Addendum No. 01

Subject: John Taggart ES – Classroom Modernization

SDP Contract Nos. B-047C, B-050C, of 2017/18

This Addendum, dated 9th of May, 2018, shall modify and become part of the Contract Documents for the work of this project. Any items not mentioned herein, or affected by, shall be performed strictly in accordance with the original documents.

DRAWING P111 - FIRST & SECOND LEVEL - PLUMBING FLOOR PLAN - NEW WORK

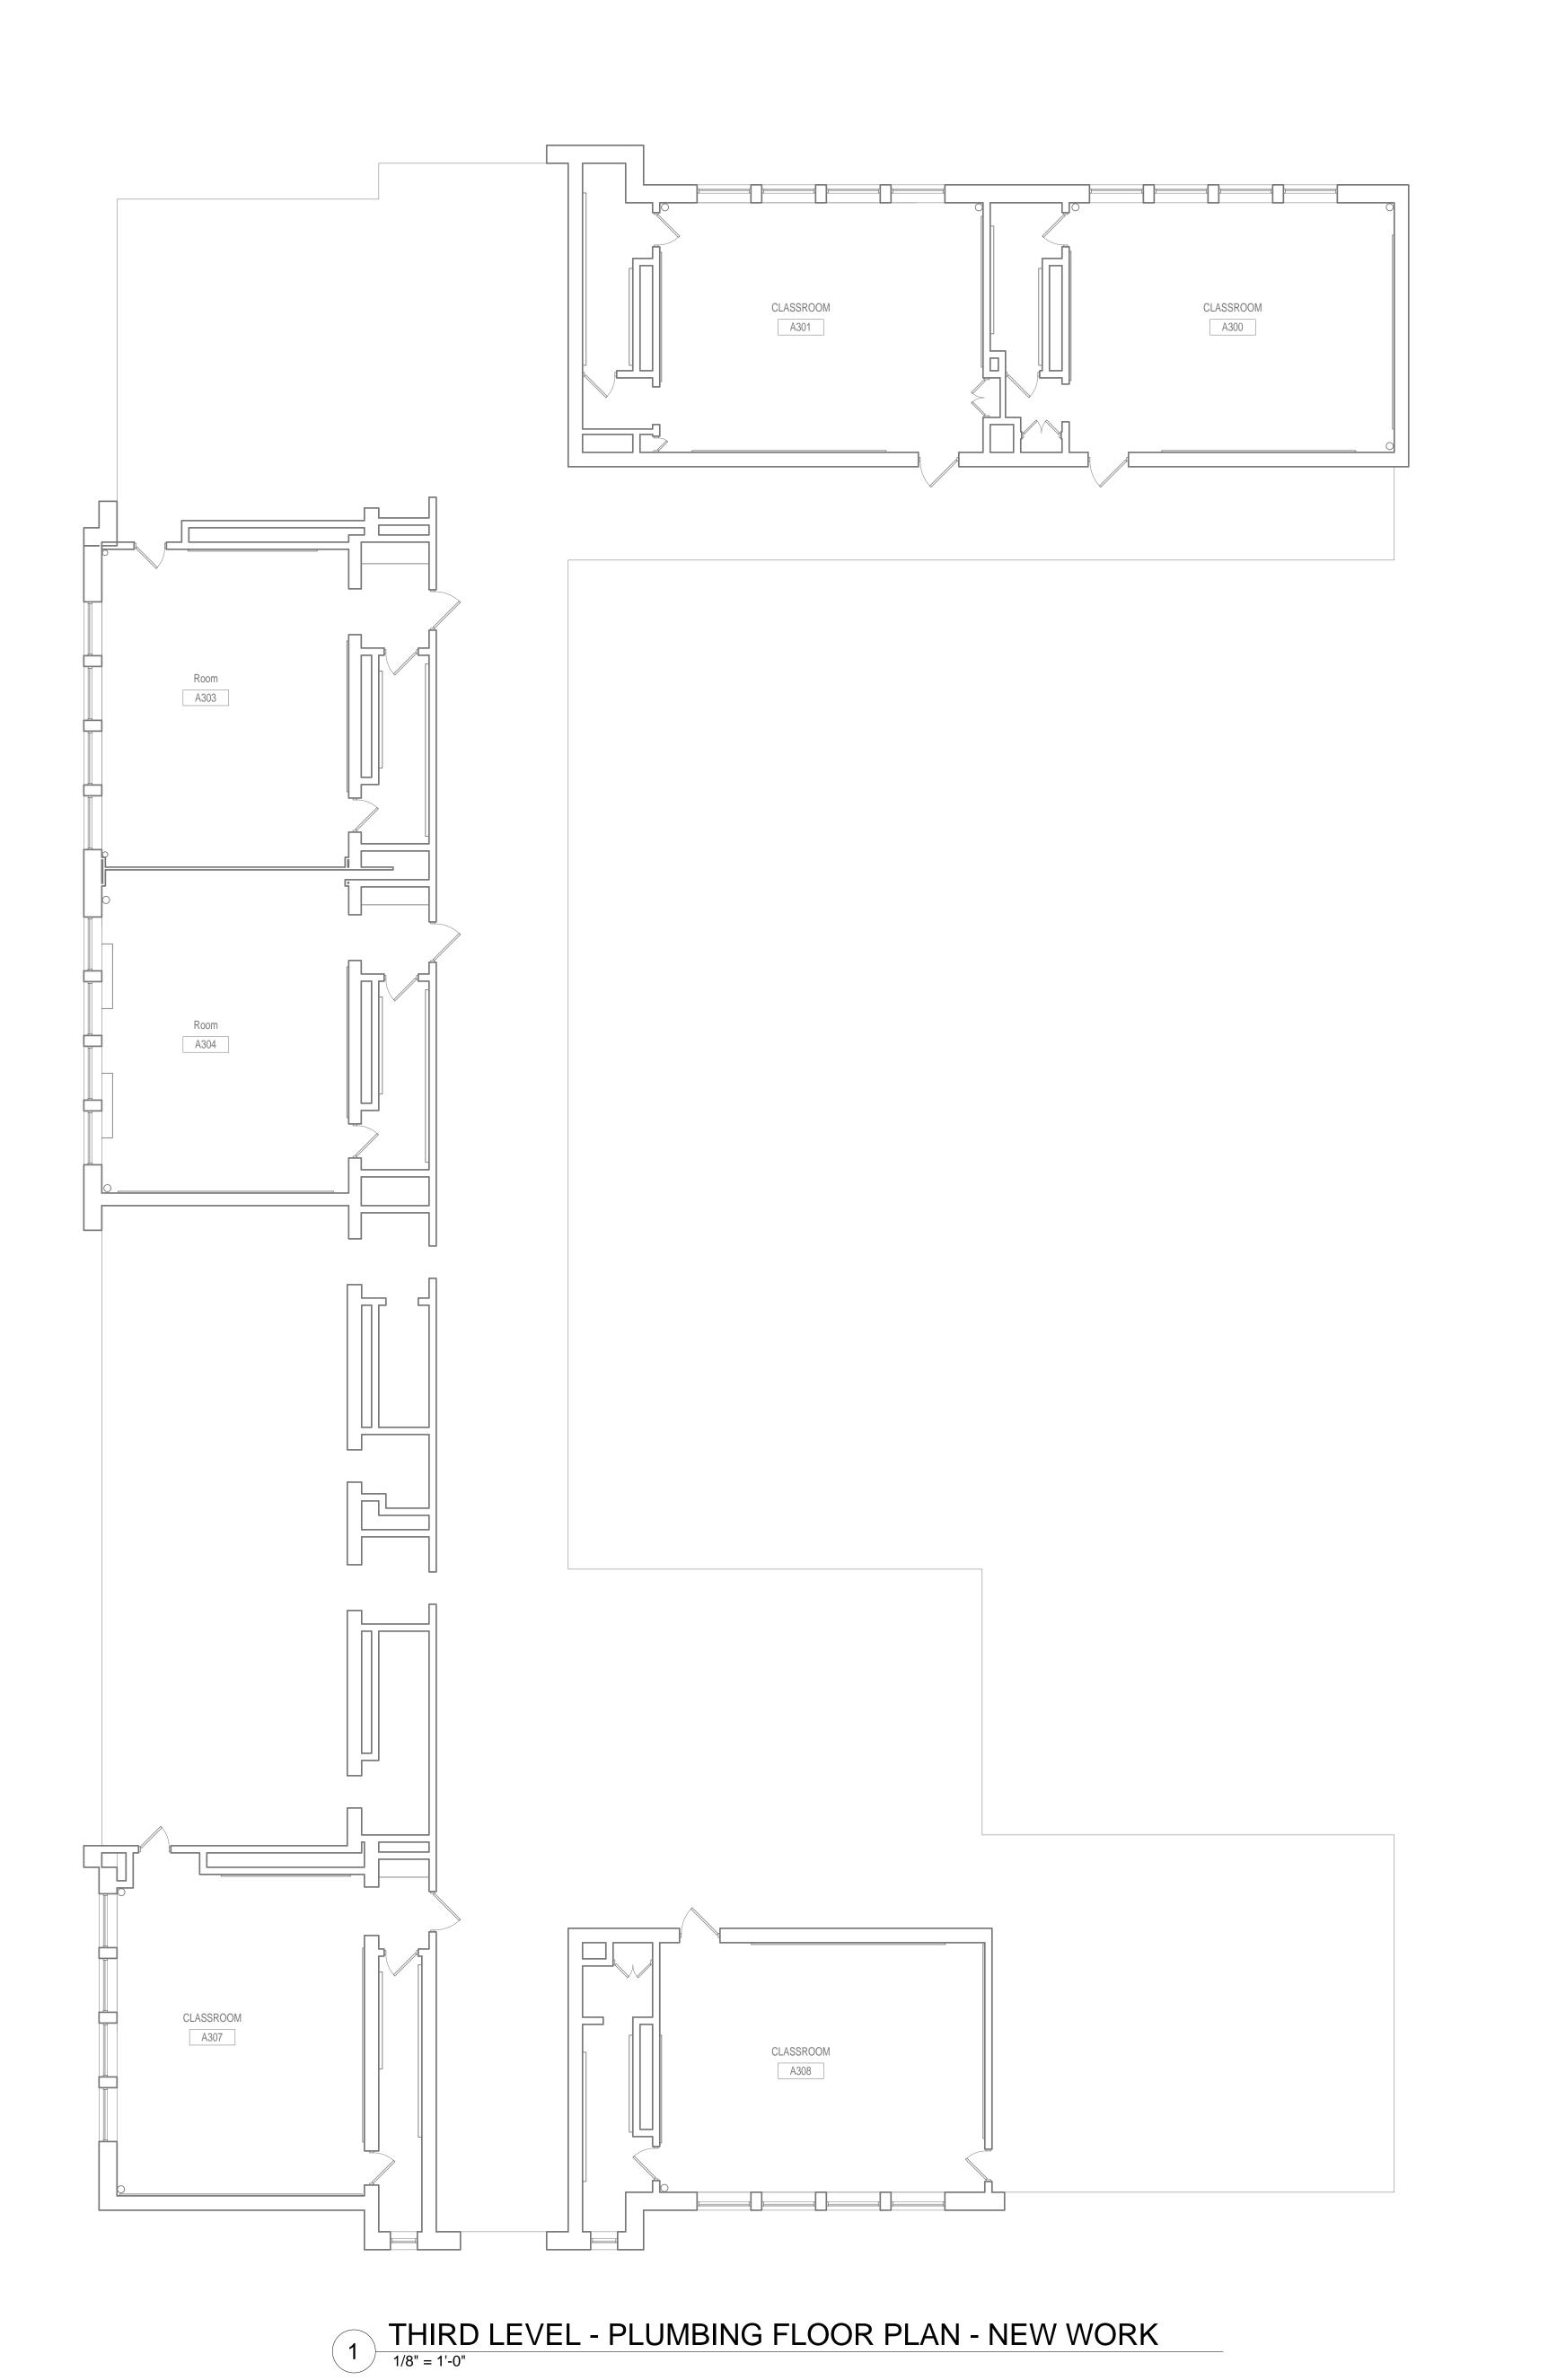
1. ADD new work general note 3 and key note 2.

ADD DRAWING P112 - THIRD LEVEL - PLUMBING FLOOR PLAN - NEW WORK

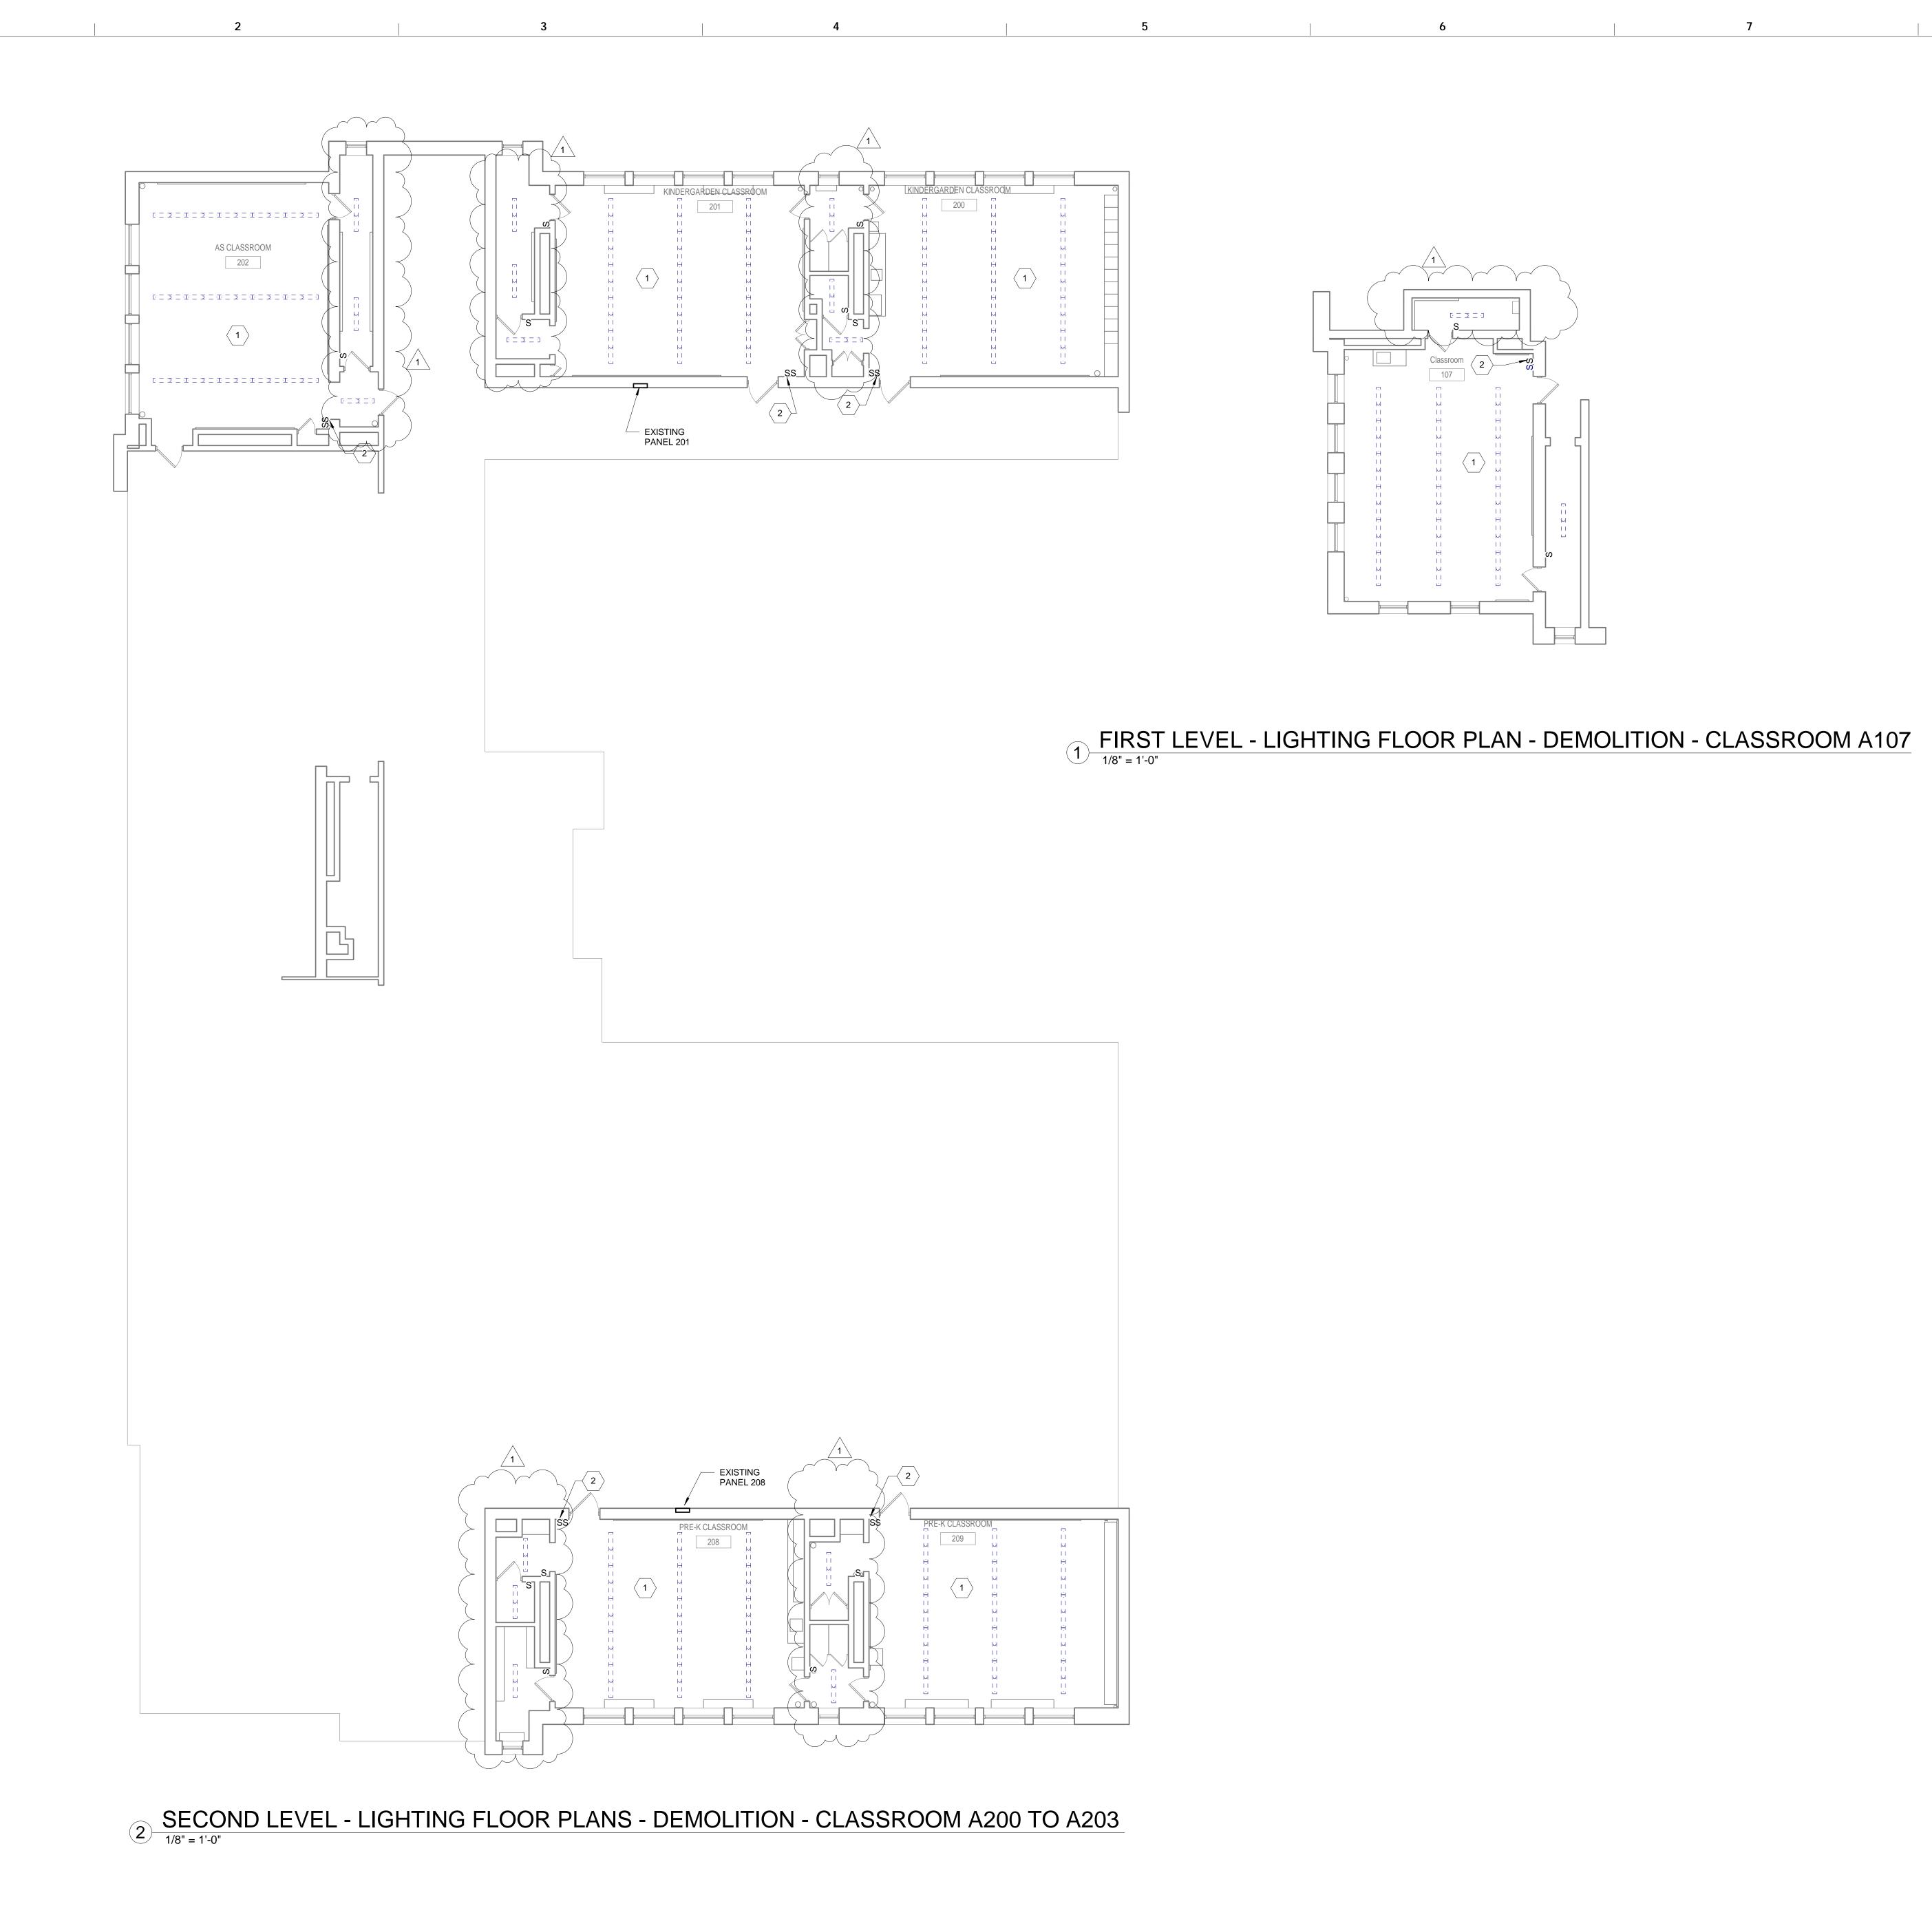
1. **REVISE** drawing list to add P112 – Third Level – Plumbing Floor Plan – New Work

1. **ADD** new work general note 3.

DRAWING ED111 - FIRST & SECOND LEVEL - LIGHTING FLOOR PLANS - DEMOLITION

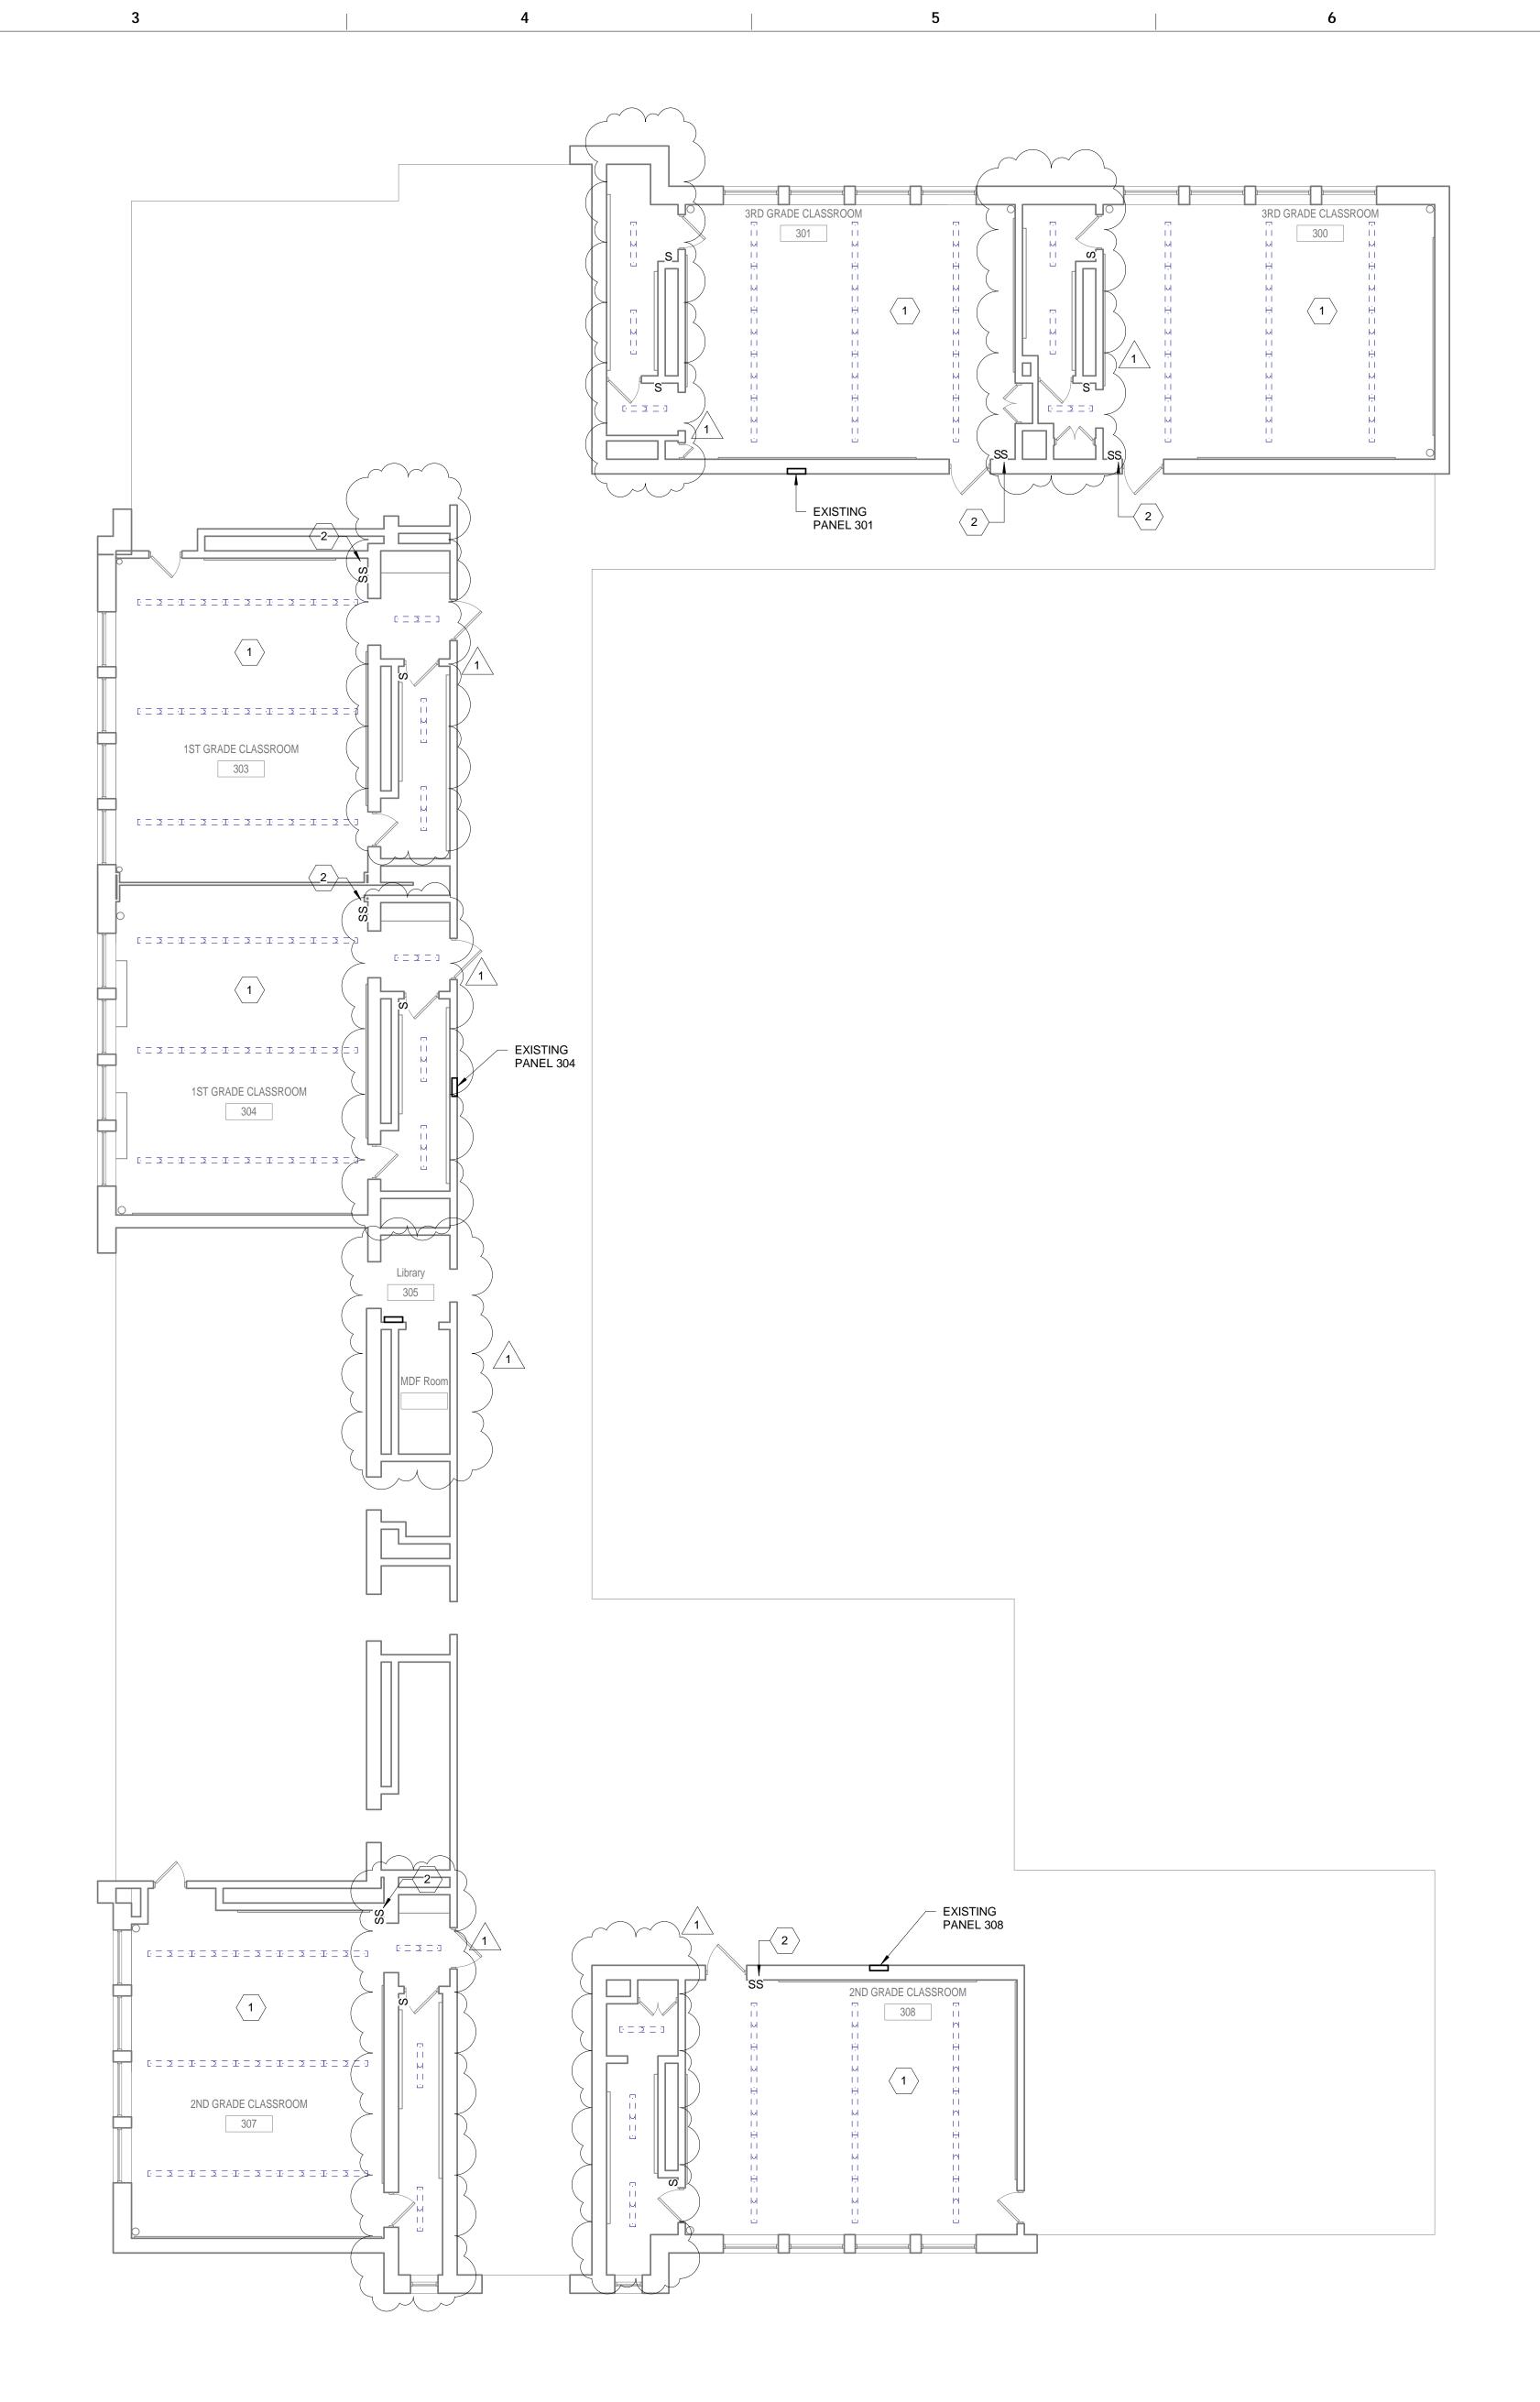
1. ADD existing lights in toilet and storage.
